Technical News

Issue 142

March 2013

Item 1.

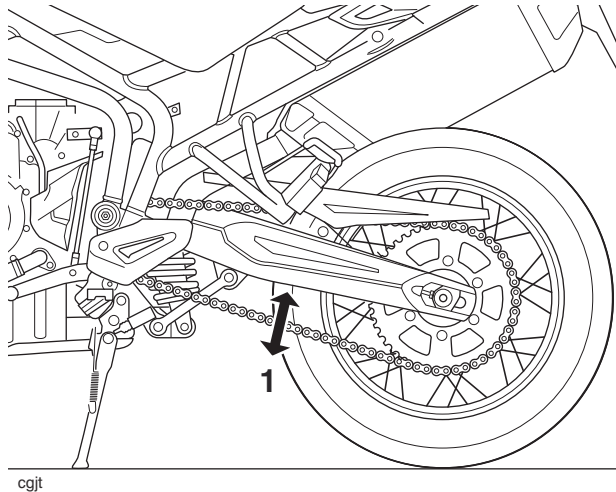
The drive chain vertical movement setting has changed to 20 - 30 mm for the above model. This change affects all bikes from the start of production.

The Tiger 800XC setting has not changed and remains as described in the service manual and owner handbook.

Item 2.

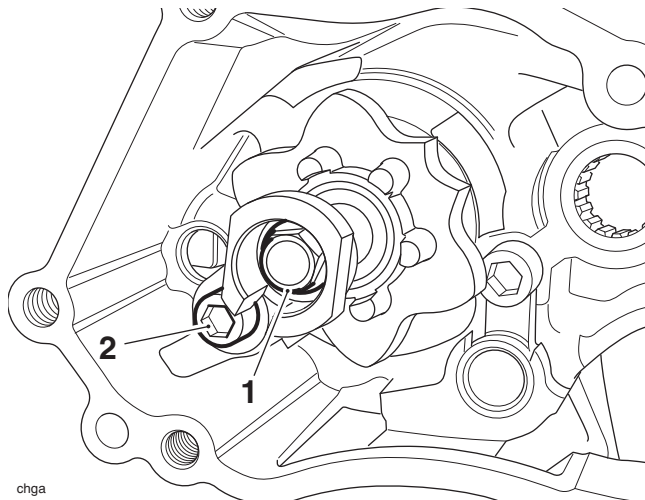
The torque figures for the detent wheel and selector drum bearing keeper plate fixings have changed on the above models. The new torque figures are as follows:

- Detent wheel fixing - **11 Nm**
- Selector drum bearing keeper plate fixing - **9 Nm**

- **Models already in service need not be re-tightened unless the fixings have been loosened or removed.**
- **The detent wheel and selector drum bearing keeper plate fixings must be replaced if they have been loosened or removed.**

Item 3.

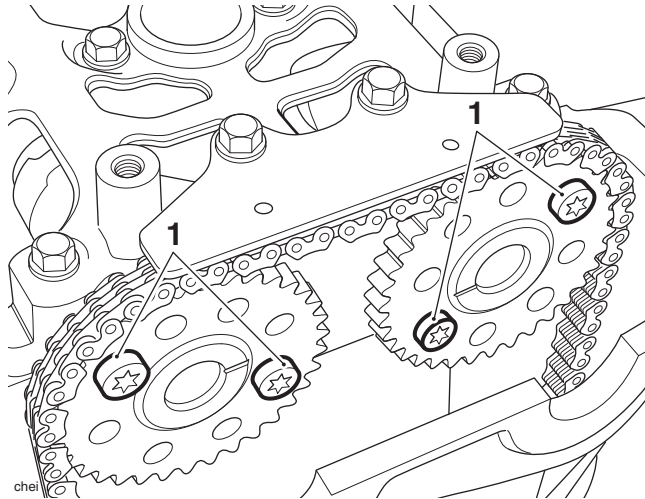
If the fixings for the camshaft sprockets have been loosened or removed they must be discarded. New fixings must be installed with a drop of ThreeBond 1375B locking compound (or equivalent) to the threads.

Item 4.

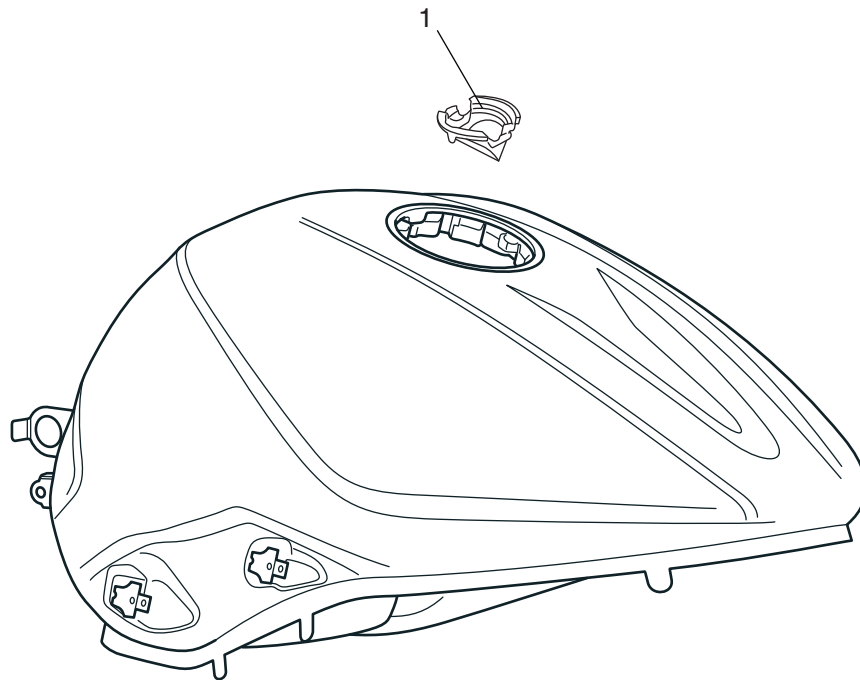
The fuel filler baffle is no longer fitted to the fuel tank on the above models from VIN 579045.

Item 5.

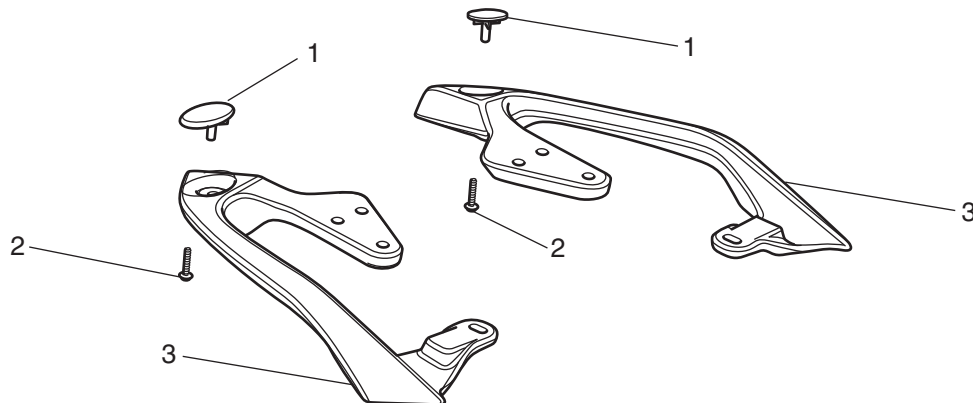
The torque figure for the fixings securing the finisher cap to the grab handles has changed to **1 Nm** on the above models.

- **Models already in service need not be re-tightened unless the fixings have been loosened or removed.**

Item 8.

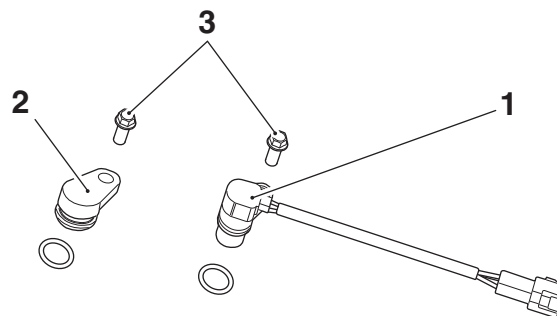
A new road speed sensor/blanking plug fixing (part number T3205064) has been introduced on the above models from VIN 574316 and is retrofittable. The torque figure has also changed to **4 Nm** to coincide with the introduction of the new fixing.

- **Models already in service need not be re-tightened unless the fixings have been loosened or removed.**
- **The road speed sensor/blanking plug fixing must be replaced if it has been loosened or removed.**

Item 9.

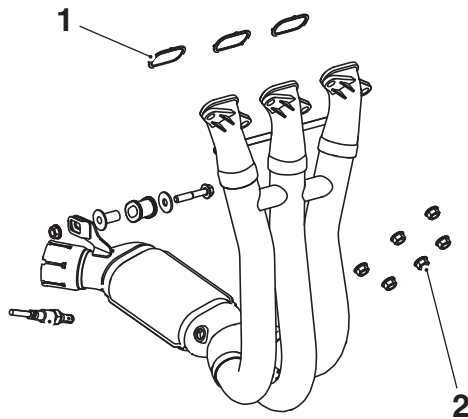
A new exhaust header seal has been introduced on the above models from VIN 584513. The torque figure for the exhaust header pipe fixings has also changed to **23 Nm** to coincide with the introduction of the new header seal.

- **Models already in service need not be re-tightened unless the fixings have been loosened or removed.**
- **The new torque figure of 23 Nm must only be applied when replacing existing header seals with the new condition header seals.**
- **When replacing existing header seals with old condition header seals, the previous torque figure of 19 Nm must be applied.**

Old Condition Seal: Part Number 2201140 Header Fixing Tightened to 19 Nm		New Condition Seal: Part Number 2201157 Header Fixing Tightened to 23 Nm	
Identification: Copper cladding on front, back and internal edge only. No copper cladding on external edge.		Identification: Completely copper clad.

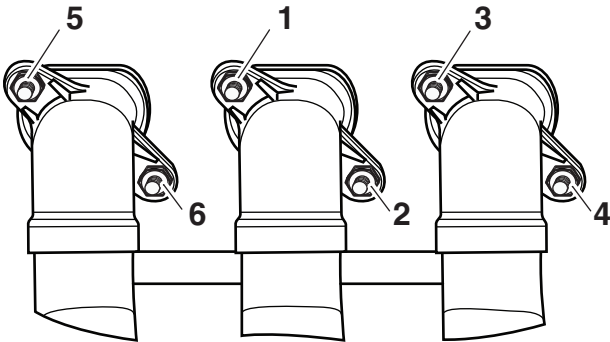
In addition there has also been a change to the exhaust header pipe fixing tightening sequence. When tightening the header pipe fixings follow the tightening sequence below.

- This tightening sequence can be applied when fitting either header seal type.

Item 11.

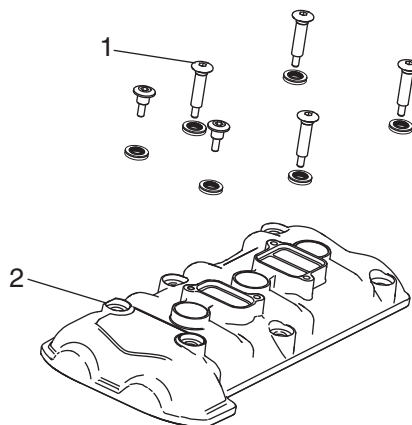
The torque figure for the camshaft cover fixings has changed to **12 Nm** on the above models.

- Models already in service need not be re-tightened unless the fixings have been loosened or removed.

Item 12.

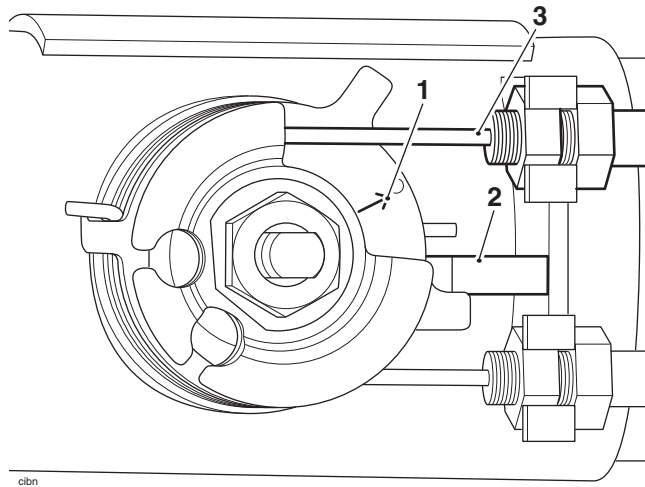
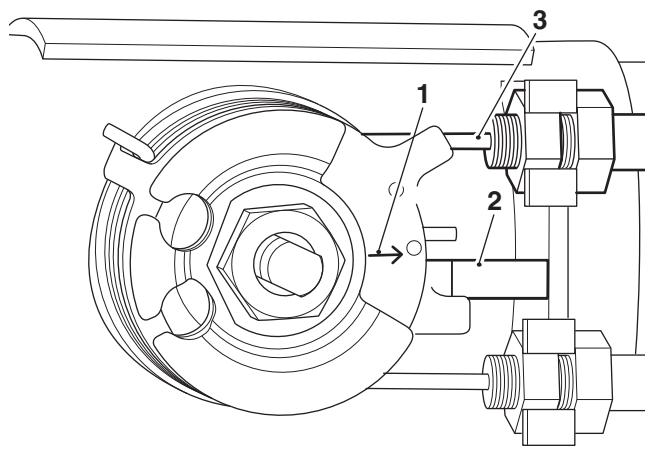
The method to adjust the exhaust butterfly valve on the above models has changed and is different to the Daytona models prior to VIN 564948. To adjust the butterfly valve and to avoid damage to the exhaust butterfly valve actuator, follow the procedure listed below.

-
10. Adjust the closing cable adjuster until the arrow on the butterfly valve pulley is aligned with the upper edge of the butterfly valve stop.
